SUBJECT: OCONEE NUCLEAR STATION (ONS) DRAFT UPDATED FINAL
SAFETY ANALYSIS REPORT (UFSAR) SUPPLEMENT

UFSAR Supplement

**Draft
February 2000**

Changes to Chapters 3, 4, 5, 6, and 9

Appendix 16.6-2
Figure 1
Units 1, 2, and 3

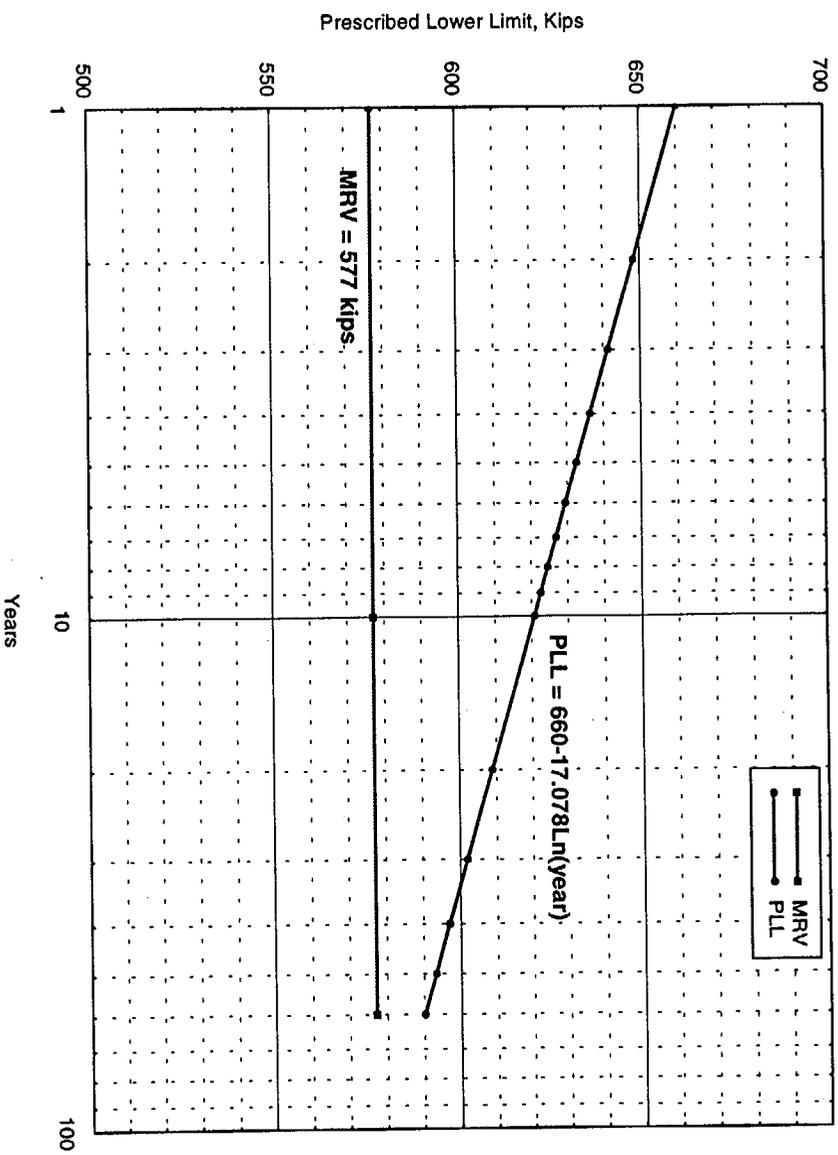
Revise Figures 1, 2, and 3 of SLC 16.6.2 as follows:

Estimated 60 Year Prescribed Lower Limit
Dome Tendons

Appendix 16.6-2
Figure 2
Units 1, 2, and 3

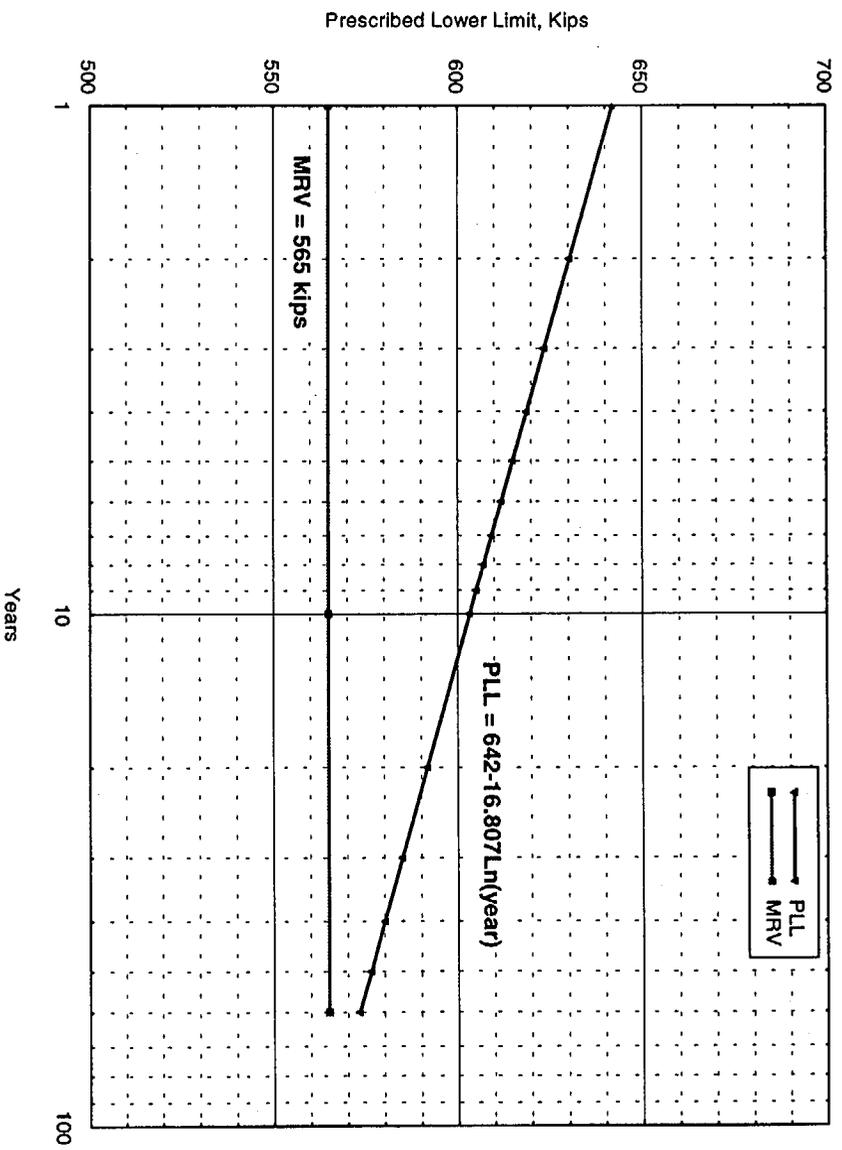
Estimated 60 Year Prescribed Lower Limit
Hoop Tendons

Appendix 16.6-2
Figure 3
Units 1, 2, and 3

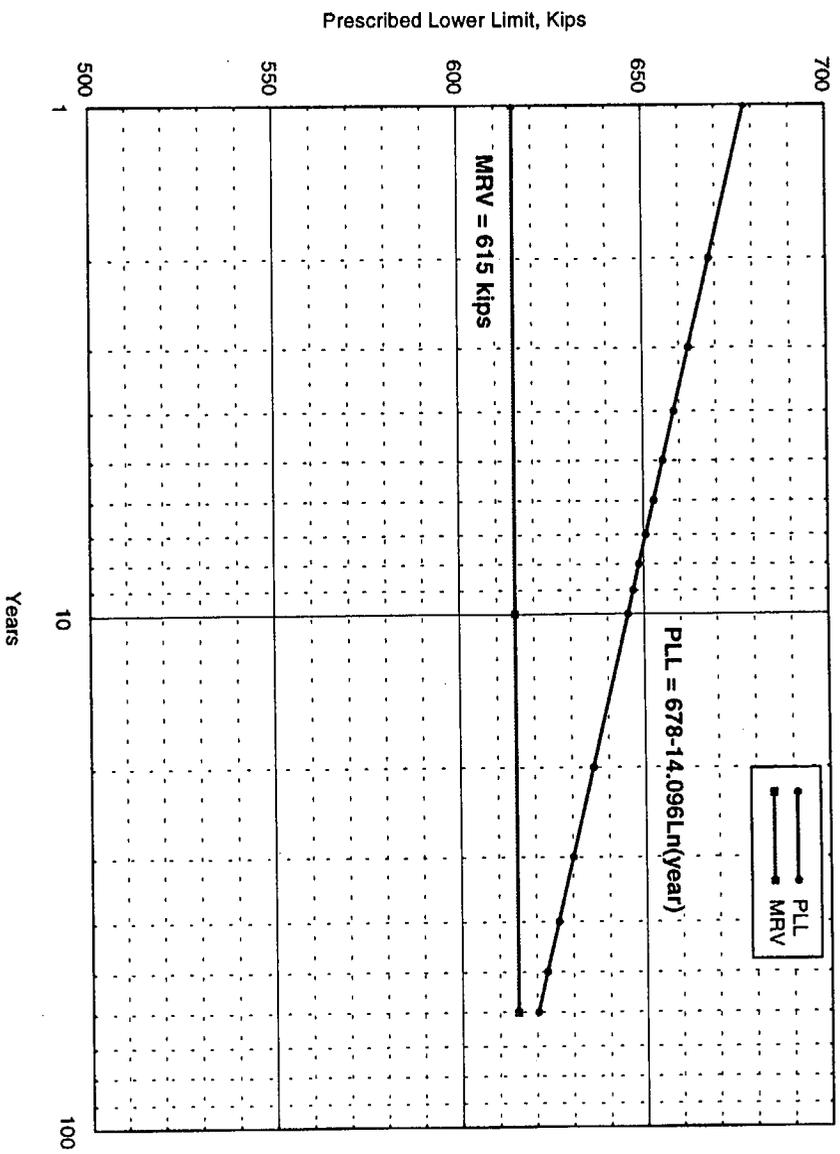
Estimated 60 Year Prescribed Lower Limit
Vertical Tendons
